State Planning Commission

AMENDMENT to the **ASSESSMENT REPORT**

For the Buckland Park Township (now Riverlea) Major Development: Second Amendment to the Environmental Impact Statement (EIS) to revise the layout of Precinct 2 and introduce a saltwater lake system.

March 2025

Figure 5: Previously Approved Layout, Figure 6: Proposed Layout (Source EIS)

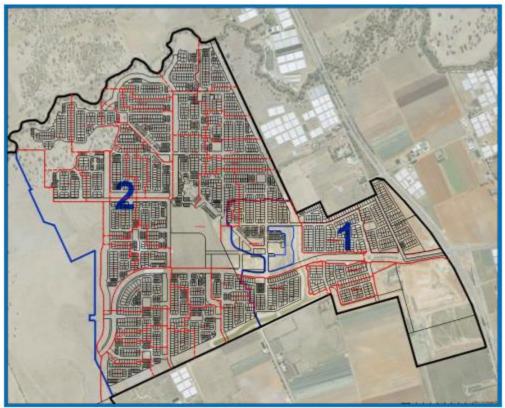
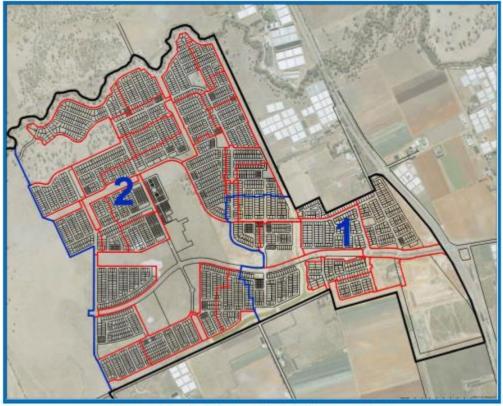
However, it is acknowledged that the layout changes (as part of the current amendment) for Precinct 2 are more substantive, involving a change to lot configuration, local road patterns, reserve distribution and deletion and/or relocation of community/centre elements (refer Figures 5 & 6 for comparison), but largely replicate the nature, form and pattern of development already under construction.

Figure 10: Stormwater treatment systems and internal catchment for SWL1 (Source EIS).

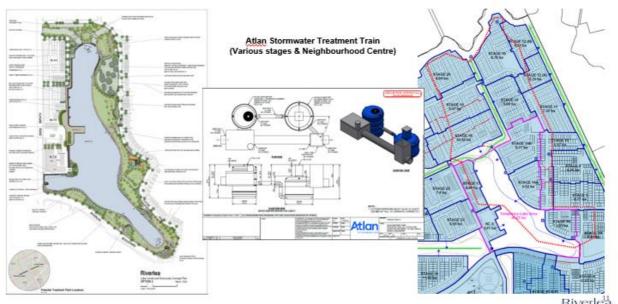
The permanent arrangement relies on a completed channel network and the construction of the three SWL. The calculations that inform this design outcome are contained in the WGA report and do not require repetition but need to be considered as an integrated system for stormwater treatment (Refer **Figure 10**) and performance – including its contribution to lake water quality.

However, the incorporation of a large detention basin at the lower end of the site (just north of the Thompson Creek channel) is worth noting, as will have an overall capacity of 250,000m³, which along with the regional drainage channels, are integral elements of the proposed system.

The positioning and function of the detention basin being situated in the lowest point of the project area, with sufficient material availability for filling and shaping, and low risk of coastal acid soils, makes this a critical component.

Figure 15: Conceptual circulation strategy and treatment plant location > purple box (WEP: October 2024).

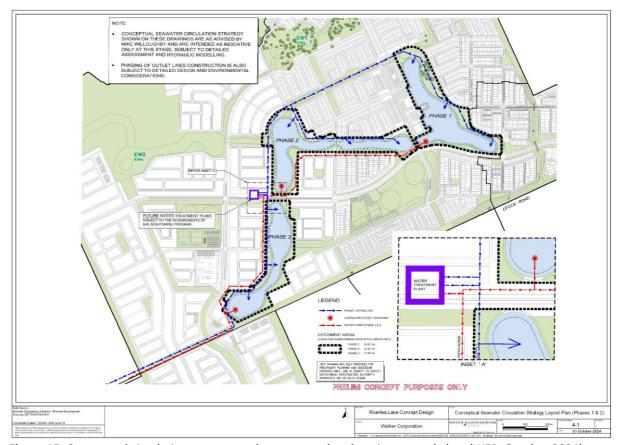
The proponent has not committed to the establishment of a treatment plant upon the initial operation of SWL1. Instead, the construction of any treatment plant would be dependent on future, detailed hydrodynamic and water quality modelling and its findings, to provide greater insight into whether the treatment plant option is needed. However, under the proponent's approach this will not be known before SWL1 is in operation and the trial period has run its course.

The threshold or trigger point would be whether there are recorded circumstances when more significant intervention (other than flushing) would be required, based on either the modelling or the trial period. Given the range of factors that could influence the water quality of SWL1, it is recommended that the treatment plant be established in parallel to the construction and operation of SWL1, or very soon after the conclusion of the initial trial period, to better regulate water quality and where needed, actively treat the water body to maintain a secondary contact standard.

The nature of the plant (i.e. layout, equipment, nutrient removal trains etc) is detailed in the S&B Lake Water Treatment Concept attached to the WEP updated Lake Concept Design (October 2024) — refer to Figure 14 below. The final design, establishment and timing of the water treatment plant should be a reserved matter.

Figure 16-17: Natural Lake Edge vs Structural Edge treatments (Source: Response Document).

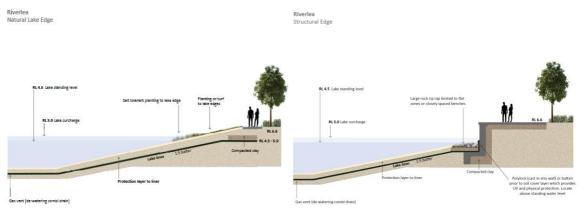
The proponent has provided a range of potential options, which can only be confirmed with the final design solution for SWL, such that both the lake specification and landscape response are recommended to be reserved matters.

Figure 17 & 18: Current (left) and Proposed Masterplan (right) (Source EIS)

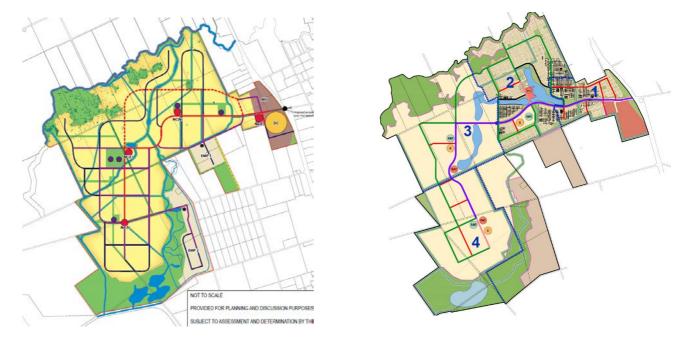
The saltwater lakes system alters the layout of the currently approved precinct 2 land division. This results in consequential changes to the layout, including the road network, reserve areas and neighbourhood centre. The current and proposed masterplan layouts are in Figures 17 and 18.

Figure 22: Burial Location 1 Resting Place in Riverlea development context (Source: DHUD-PLUS)

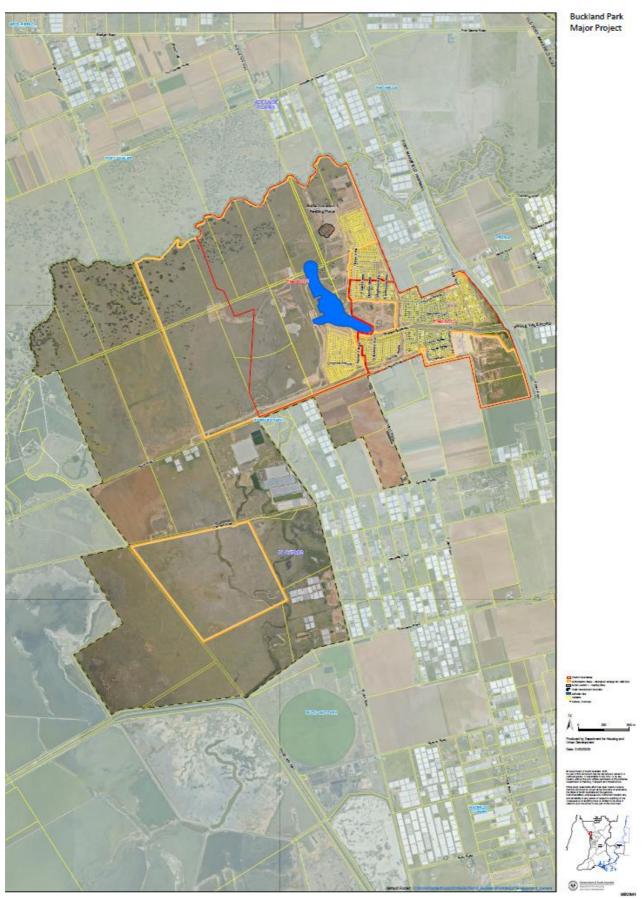
Figure 22 shows the location of the Burial Location 1 Resting Place in the context of the existing development, precinct boundaries and authorisation area.

- 23. All works and activities associated with the development undertaken in the authorised areas depicted on the map at Figure 22 within the Assessment Report must comply at all times with the conditions of the authorisations granted by the Minister for Aboriginal Affairs on 9 October 2024 under sections 21, 23 and 29(1)(b) of the *Aboriginal Heritage Act 1988* (SA). Further authorisations must be obtained from the Minister for Aboriginal Affairs before Aboriginal heritage is impacted outside of these areas.
